**Appeal (PLN25-00561) of Development
Review Officer's Approval of an Architectural
Review (PLN25-00295) of Proposed Addition
at 2892 Mesquite Dr., Santa Clara, CA 95051**

Request to clarify and make Approval Conditions
P3 and P4 objectively enforceable

**City of Santa Clara Planning Commission Meeting
February 11, 2025**

Sight line: current status

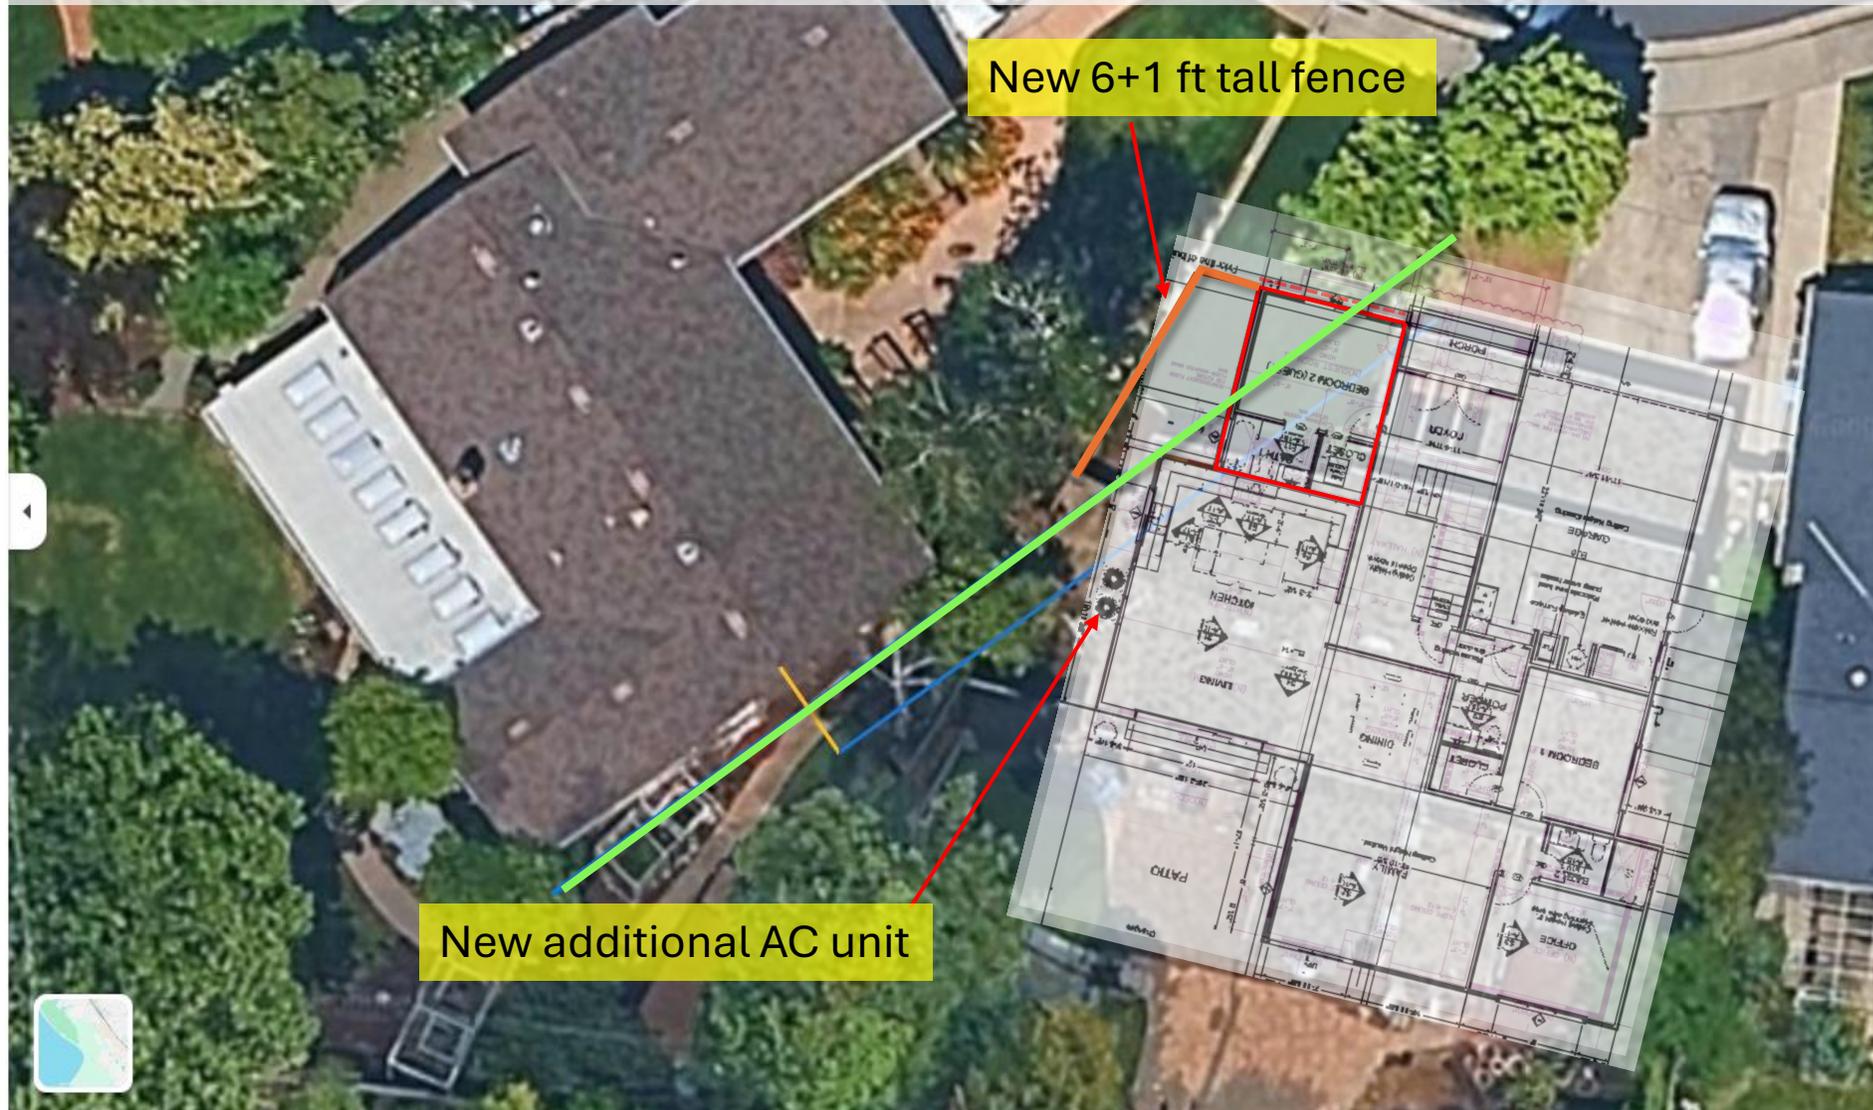
Sight line at 4.5 ft from home wall (tangent to 2892 corner)

Sight line at 10 ft from home wall as for properties on rectangular lots

Sight line: current status vs initial vs new plan

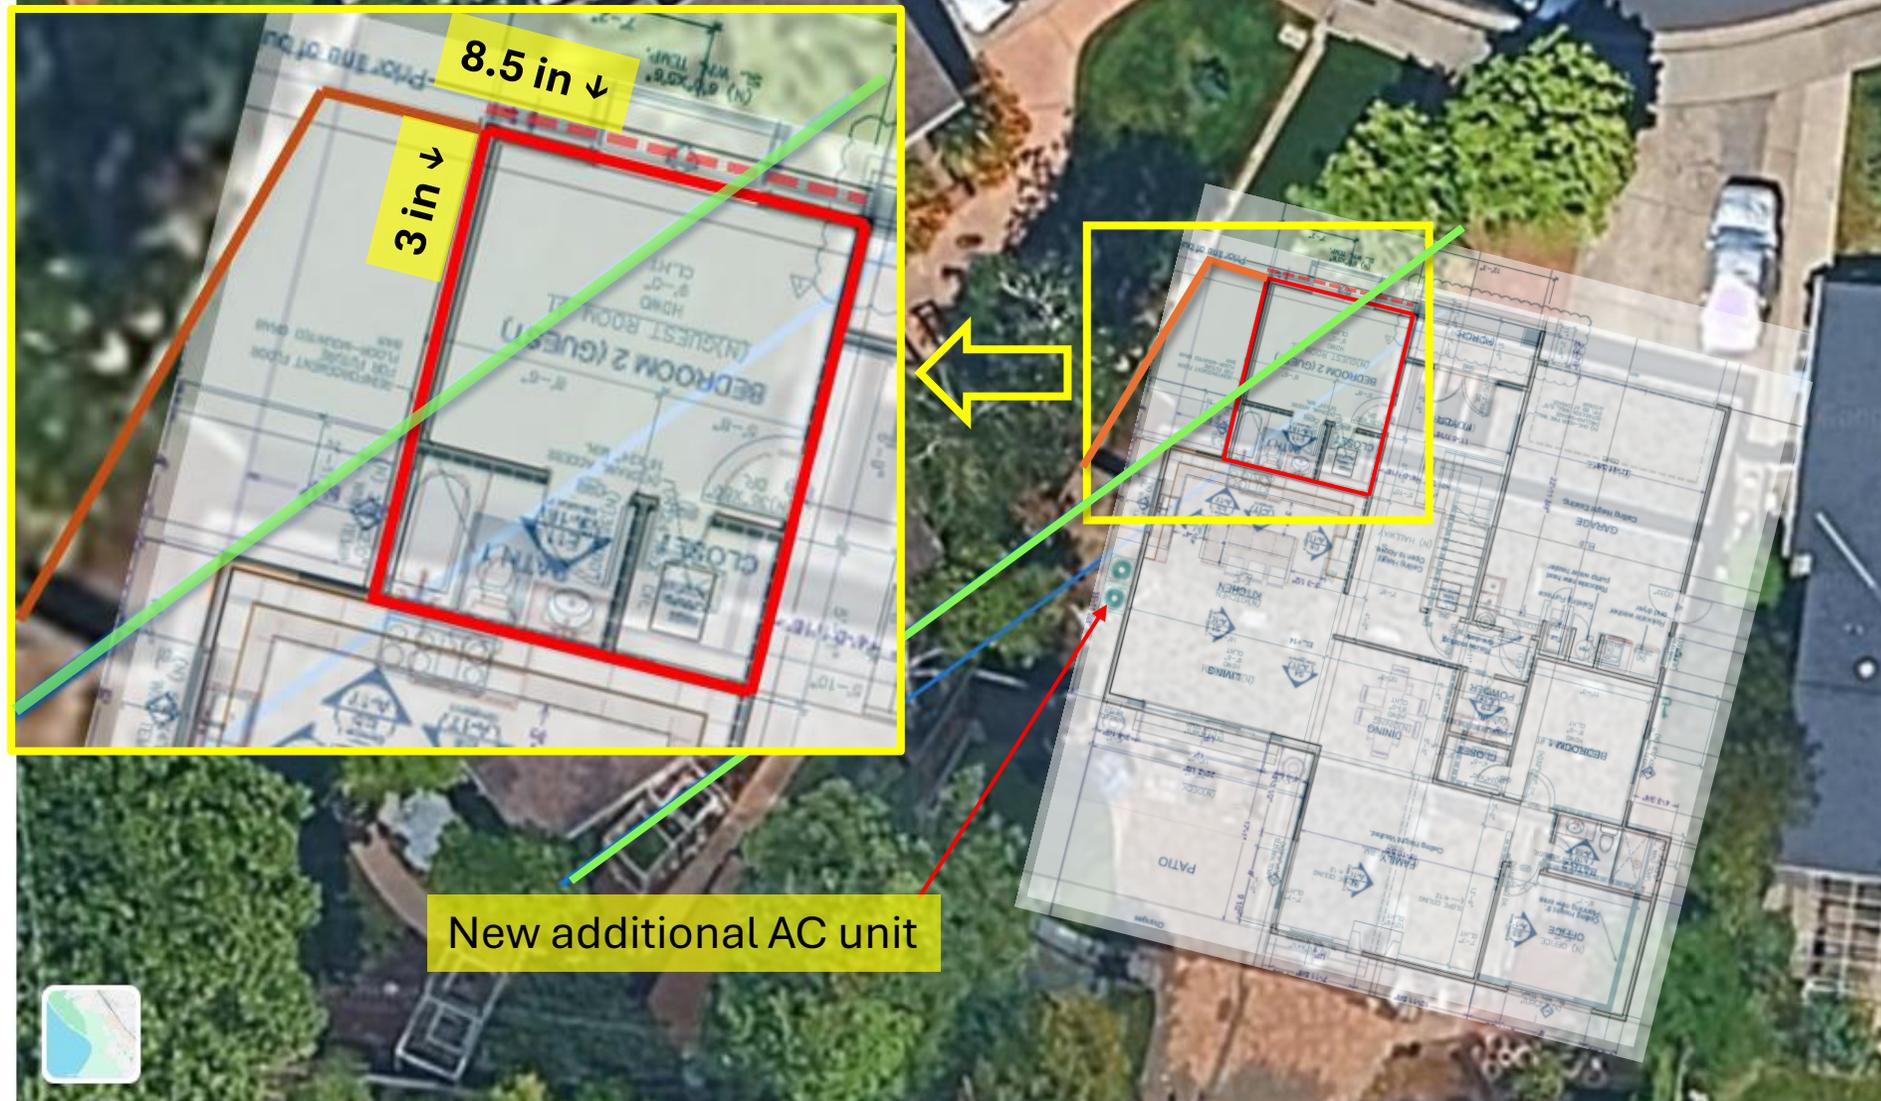
The corner of the new front bedroom was moved away from our home by 8½" and 3" respectively. **Negligible compared to the distance to the current sight line.**

- Token footprint reduction: 3" × 8.5" does not improve sight line.
- The front part of the newly proposed 6+1ft fence further obstructs sight line.
- Additional AC unit / placement will increase noise exposure.

Photos with new extension and new fence simple rendering

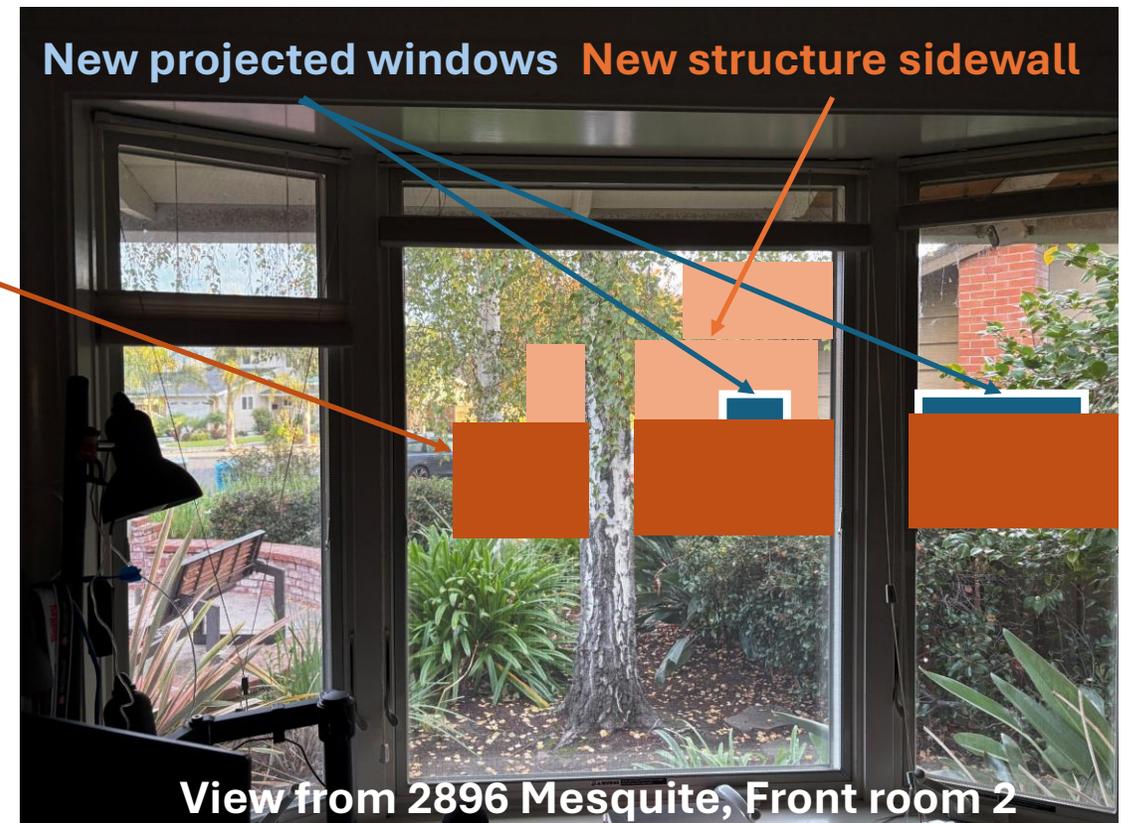
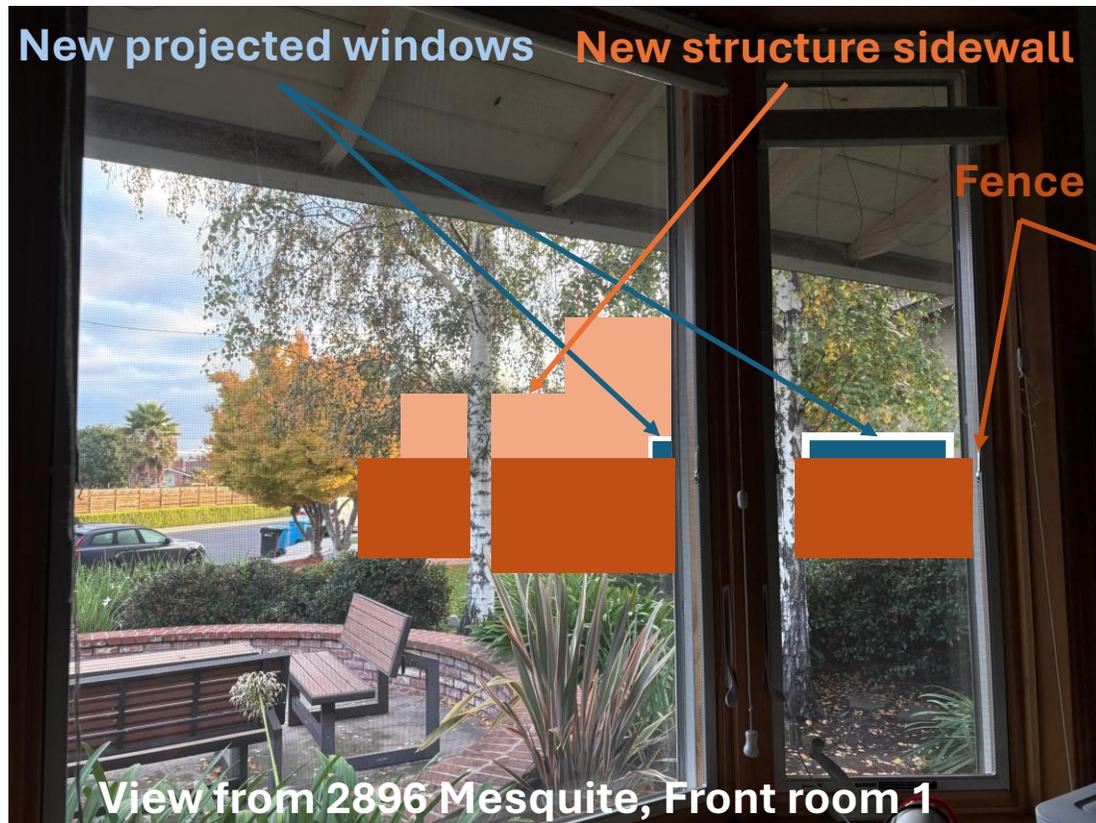
This new appearance would further diminish the enjoyment of our home and lower its value and desirability.

Photos with current structure

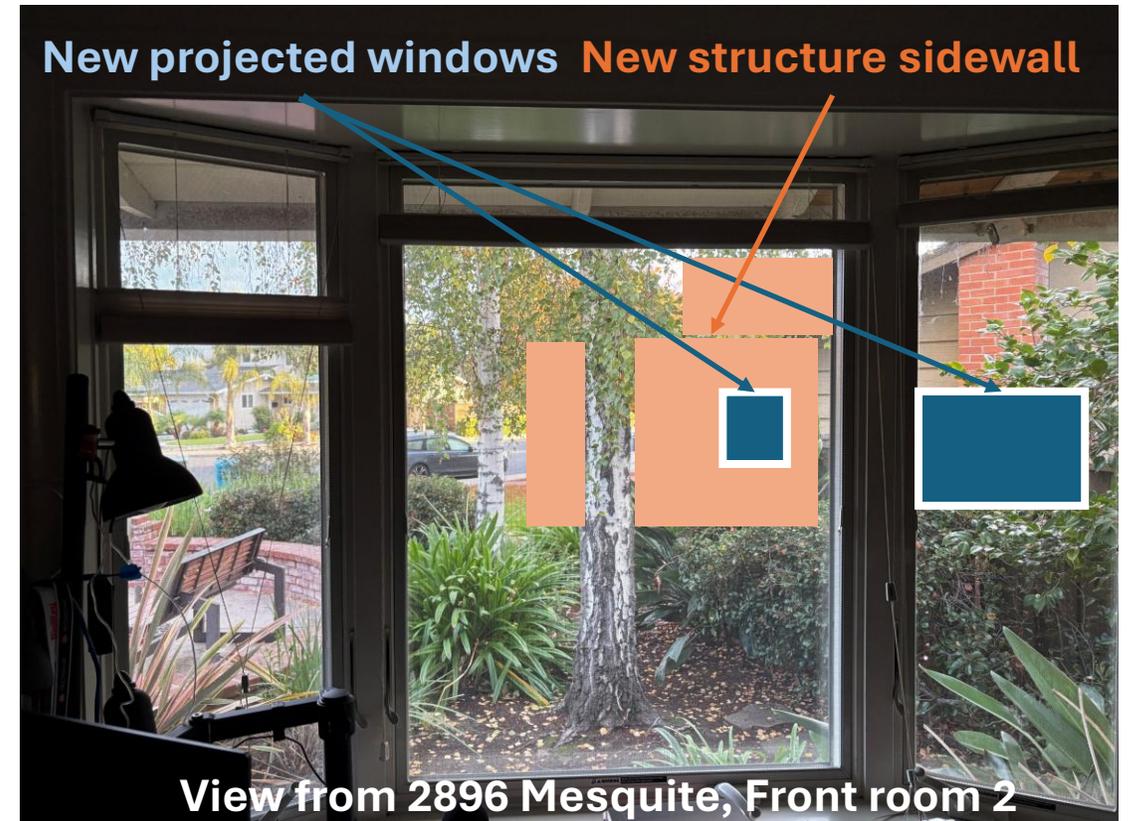
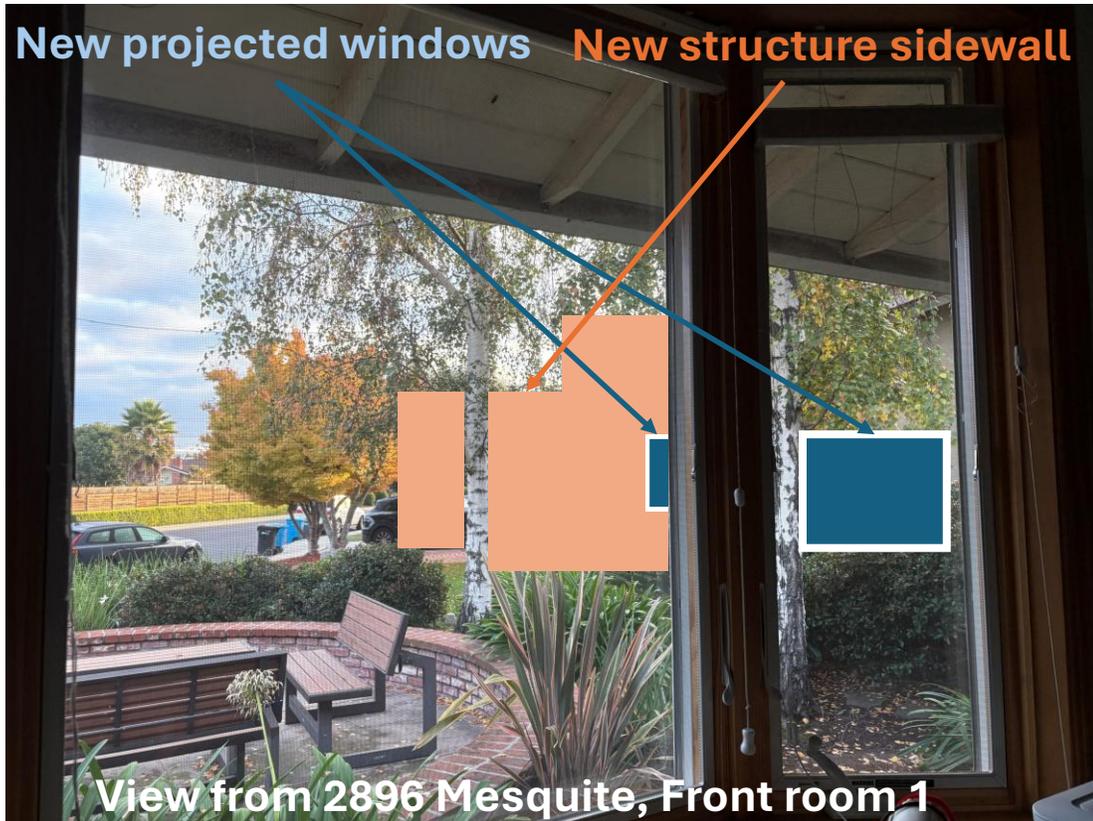
- P3 is still vague and lacks a measurable compliance standard. P3 does not define:
 - The target setback plane or a numeric setback requirement,
 - What constitutes “prevailing development pattern,”
 - What “preserve the existing sight line” means as an objective standard, or
 - How compliance will be demonstrated and verified (e.g., specific plan-view diagrams, fixed reference points, sight line corridor definition).
- P3 is currently open to interpretation and invites disputes at plan check and inspection

Photos with new extension and new fence simple rendering

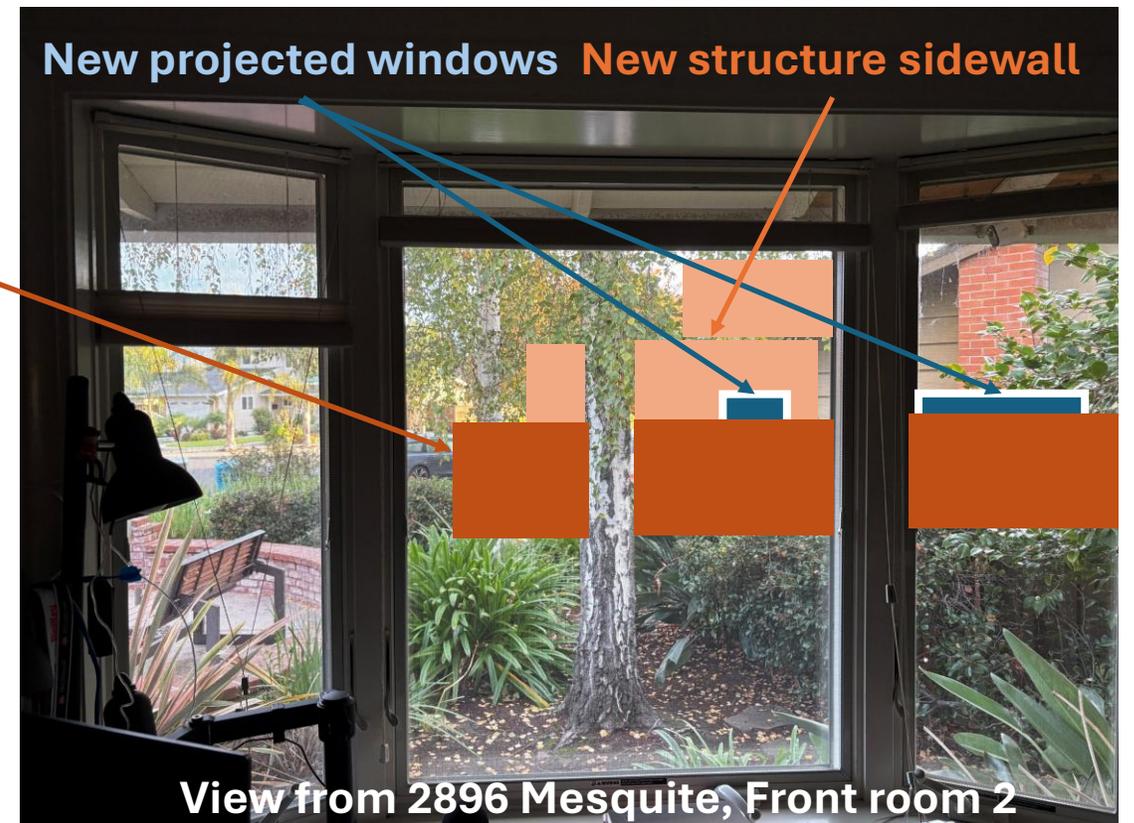
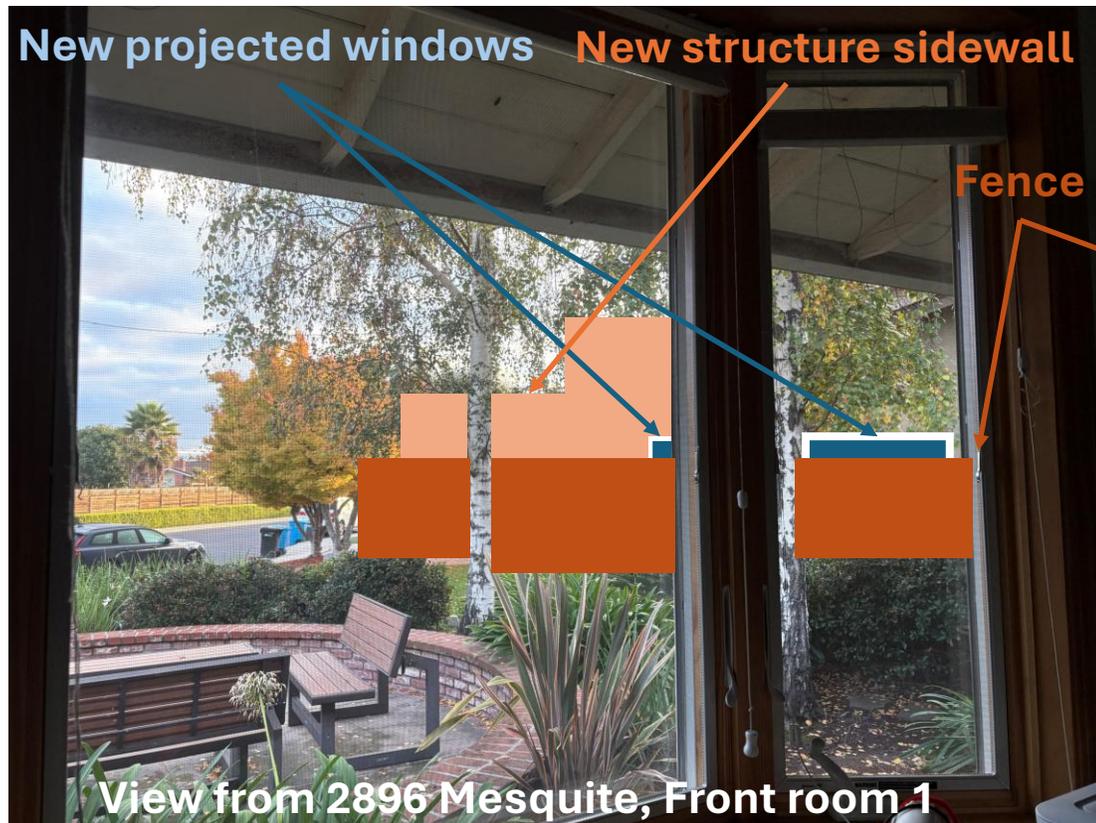
This new appearance would further diminish the enjoyment of our home and lower its value and desirability.
